COLLIER COUNTY TRANSPORTATION
CORONADO PKWY. & HUNTER BLVD.
GOLDEN GATE BEAUTIFICATION, M.S.T.U.

HUNTER BLVD LANDSCAPE PLAN

SHEET NO.
LD-21

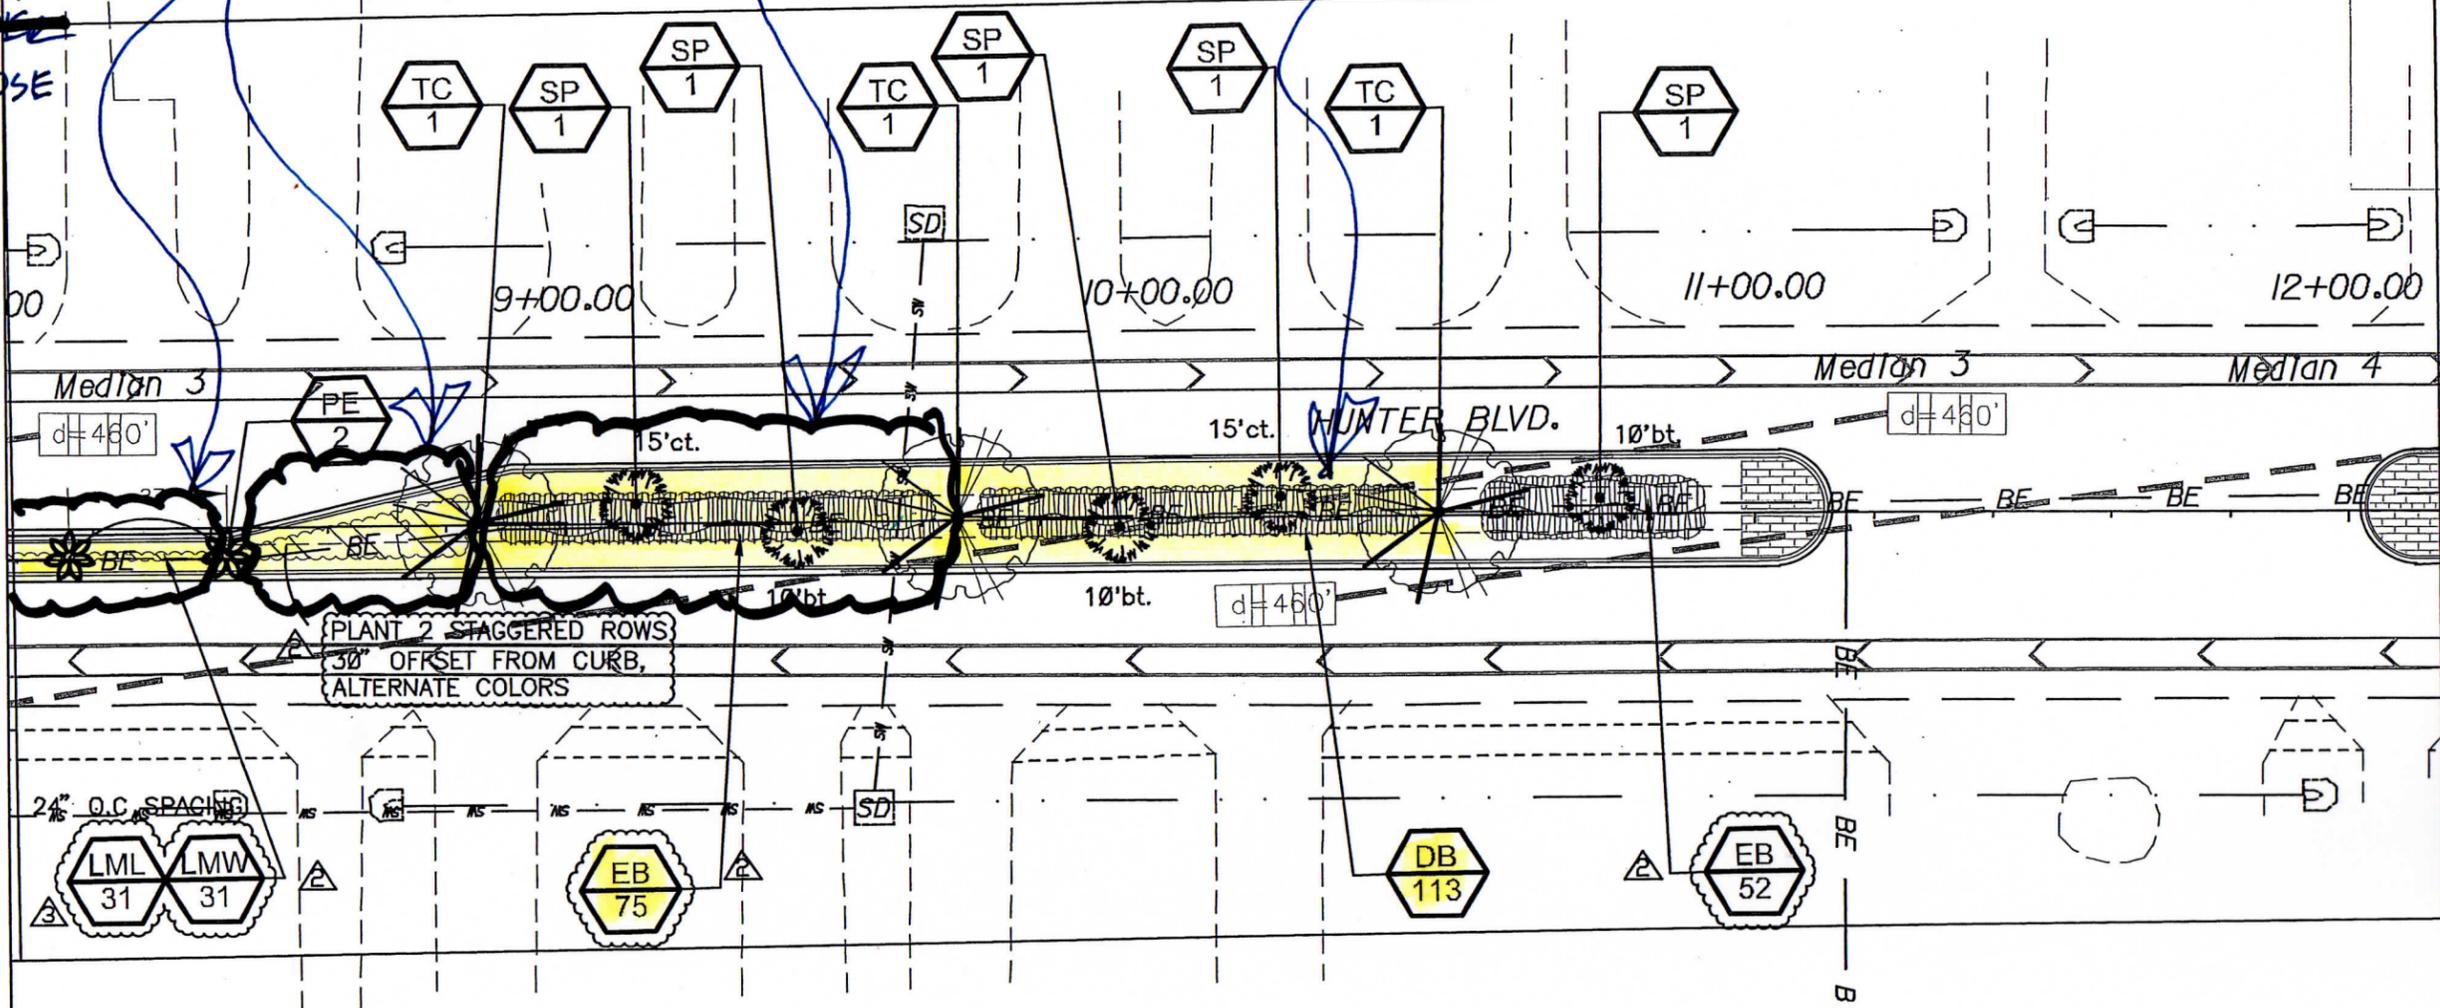
REMOVE LANTANA
REPLANT WITH
~~SUNPINE~~
BIG ROSE

REMOVE LANTANA
REPLANT WITH FLAX
LILY

REMOVE BIG ROSE
REPLANT WITH MIXED
BOUGAINVILLEA MS ALICE
AND SILHOUETTE

FILL IN MISSING FLAX LILY
